# **Hydrologic Aspects of the Updated Addendum to the Environmental Impact Statement for the DPM Lead-Zinc Mine, North Sumatra, Indonesia**

Steven H. Emerman, Ph.D., Malach Consulting, LLC, 785 N 200 W, Spanish Fork, Utah 84660, USA, Tel: 1-801-921-1228, E-mail: SHEmerman@gmail.com

Report written for Inclusive Development International  
Submitted on August 4, 2021, Revised on August 8, 2021

**Figure 2.49 Emergency Spillway Diagram**

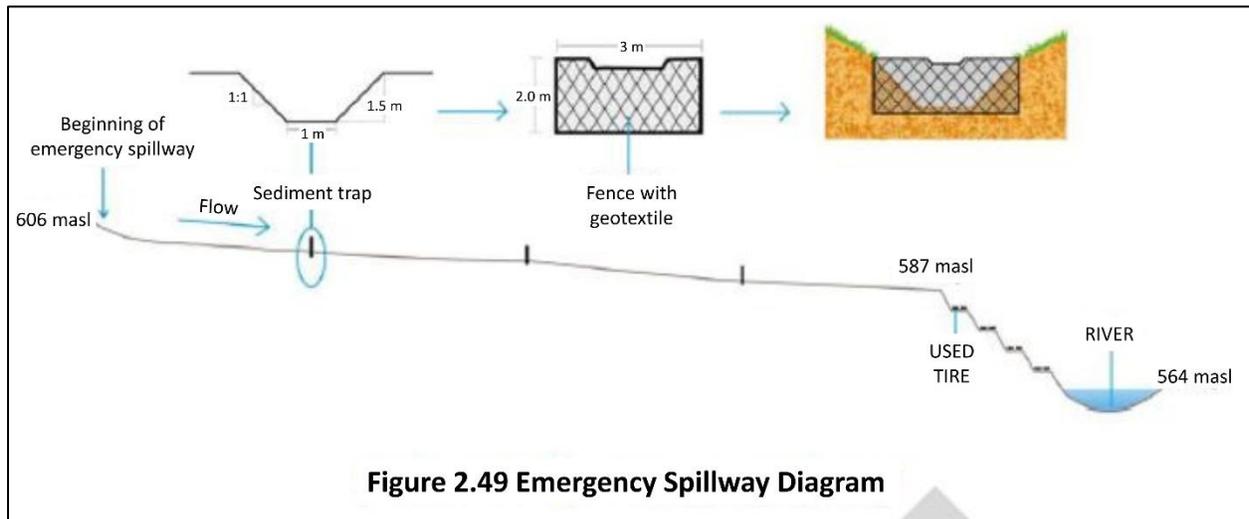
The diagram of the emergency spillway from DPM (2021) (see Fig. 1) clarifies that any tailings pond water that flows through the emergency spillway will enter downstream waterways with no passive or active treatment for the removal of contaminants. The only treatment will be the removal of sediment (fine tailings) due to the passage of the spillway flood through a sediment trap, which would be only a geotextile fence across a constructed channel (see Fig. 1). There is no discussion in DPM (2021) of the circumstances under which obstruction of the flow by the geotextile will cause overtopping of the fence and/or the banks of the constructed channel

followed by entry of the tailings pond water into downstream waterways without even any sediment (fine tailings) removal. There is also no discussion of the time that will be required for the geotextile to become clogged with fine tailings or any procedures for cleaning or replacement of the geotextile. Of course, once the geotextile becomes clogged, there will be a continuous overtopping of the fence and/or the banks of the constructed channel. Finally, there is no discussion of the dimensions or slope of the constructed channel that should be required to accommodate the overflow that will occur whenever the monthly rainfall exceeds 322.7 mm.

**Figure 1.** The above figure clarifies that any tailings pond water that flows through the emergency spillway will enter downstream waterways with no passive or active treatment for the removal of contaminants. There is no discussion of the circumstances under which obstruction of the flow by the geotextile will cause overtopping of the fence and/or the banks followed by entry of the tailings pond water into downstream waterways without even any sediment (fine tailings) removal. There is also no discussion of the time that will be required for the geotextile to become clogged with fine tailings or any procedures for cleaning or replacement of the geotextile. Figure from DPM (2021) with overlay of English labels.

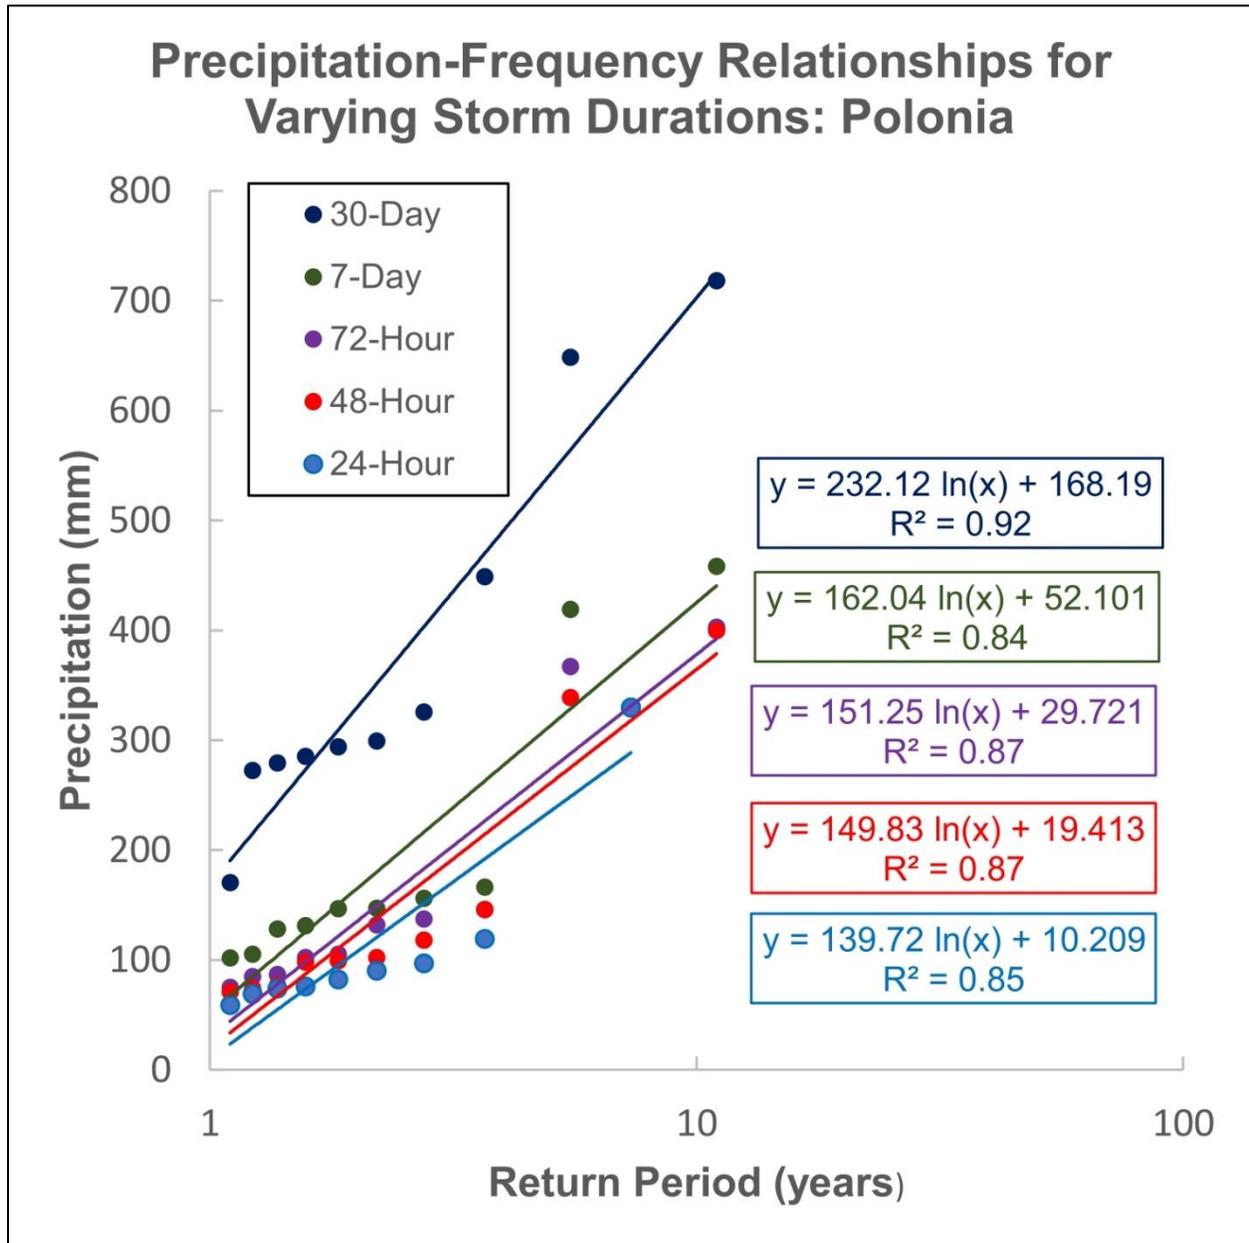
For the Polonia weather station, the ratio of the predicted precipitation event with a return period of 100 years to the average precipitation is 153.2, 83.1, 56.7, 26.8, and 9.8 for storms with durations of 24 hours, 48 hours, 72 hours, 7 days, and 30 days, respectively (see Table 1). For example, the 100-year storm with a duration of 24 hours is predicted to have 653.6 mm of

precipitation, while the average daily precipitation is 4.3 mm. The 100-year rainy period with a duration of 30 days is predicted to have 1237.1 mm of precipitation, while the average precipitation over 30-day periods is 126.2 mm. For comparison, the average monthly precipitation at the mine site weather station was 197.8 mm, which is consistent with its higher elevation (see Fig. 6). It is emphasized that precipitation data from the Polonia weather station is not being used to predict the magnitude of 100-year storms at the mine site, but to illustrate the principle that design for the 100-year storm with duration of 24 hours is far more conservative (more protective of people and the environment) than design for the 100-year rainy period with duration of 30 days. Thus, the design of the tailings dam for the 100-year flood in the updated Addendum (DPM, 2021) is far less conservative (for prevention of tailings dam failure by overtopping) than was assumed to be the case in the review by Emerman (2020) of the original Addendum (DPM, 2019).

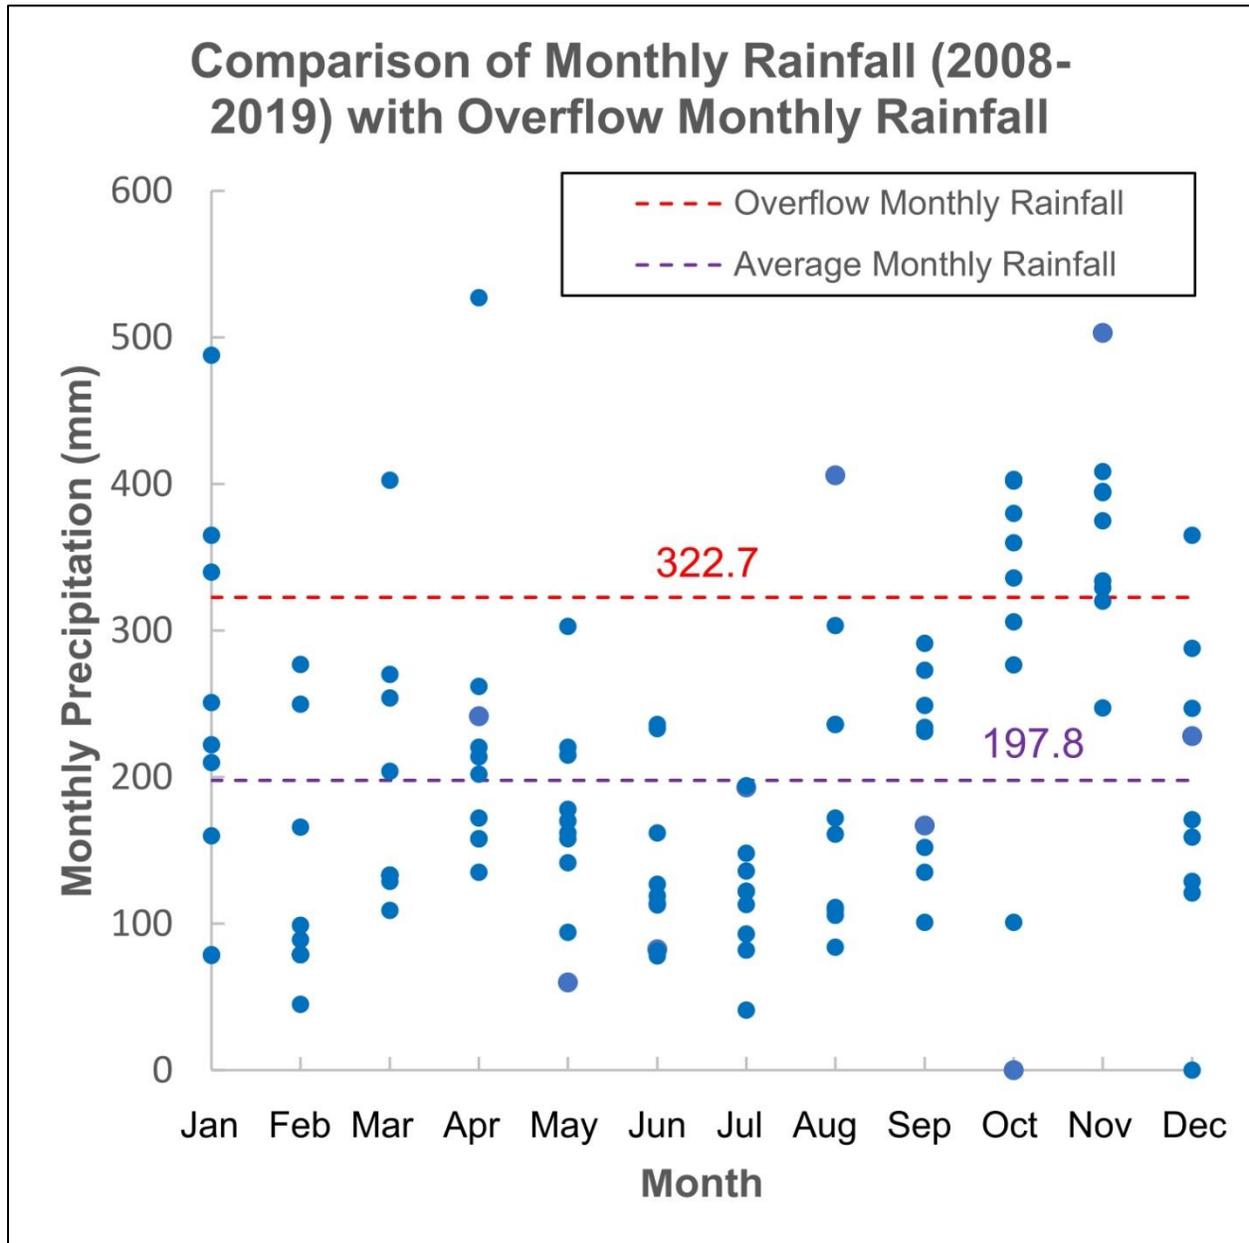
Based on a comparison of monthly precipitation data from the mine site weather station for 2008-2019 (see Fig. 3a) and an overflow monthly rainfall of 322.7 mm, the toxic and acidic tailings pond water will be flowing without treatment into downstream water bodies 20 out of every 137 months, or 15% of the time (see Fig. 6). Such a frequent discharge of untreated mine wastewater into downstream water bodies must be regarded as unacceptable by any standard. The basis for the overflow monthly rainfall of 322.7 mm is the statement “*diketahui bahwa pada tahun 2009 hingga tahun 2018, curah hujan rata-rata tertinggi tercatat pada bulan November yaitu 322,7 mm*” [it is known that from 2009 to 2018, the highest average rainfall was recorded in November, which was 322.7 mm]. However, based on the data in Table 4.7 of DPM (2021) (see Fig. 3a), the average monthly rainfall for November for 2009-2018 was 328.7 mm, while the average was 344.5 mm for 2008-2018 (the highest November rainfall was 503 mm in 2008). There is no explanation in DPM (2021) as to how the overflow monthly rainfall could be set so precisely (to the nearest 0.1 mm).

**Figure 6.** According to DPM (2021), after closure of the tailings dam, the tailings pond water will flow through the emergency spillway and enter the Lae Sopokomil river whenever “*curah hujan melebihi curah hujan rerata bulanan tertinggi (322,7 mm)*” [rainfall exceeds the highest average monthly rainfall (322.7 mm)]. Based on monthly precipitation data from the mine site weather station for 2008-2019 (see Fig. 3a) and an overflow monthly rainfall of 322.7 mm, the tailings pond water will be flowing into downstream water bodies 15% of the time. According to DPM (2021), “*diketahui bahwa pada tahun 2009 hingga tahun 2018, curah hujan rata-rata tertinggi tercatat pada bulan November yaitu 322,7 mm*” [it is known that from 2009 to 2018, the highest average rainfall was recorded in November, which was 322.7 mm]. However, based on the data in Table 4.7 of DPM (2021) (see Fig. 3a), the average monthly rainfall for November for 2009-2018 was 328.7 mm, while the average was 344.5 mm for 2008-2018 (the highest November rainfall was 503 mm in 2008). Based on the same data for 2008-2019, the average monthly rainfall for all months is 197.8 mm (see Fig. 3a). Data from Table 4.7 in DPM (2021).
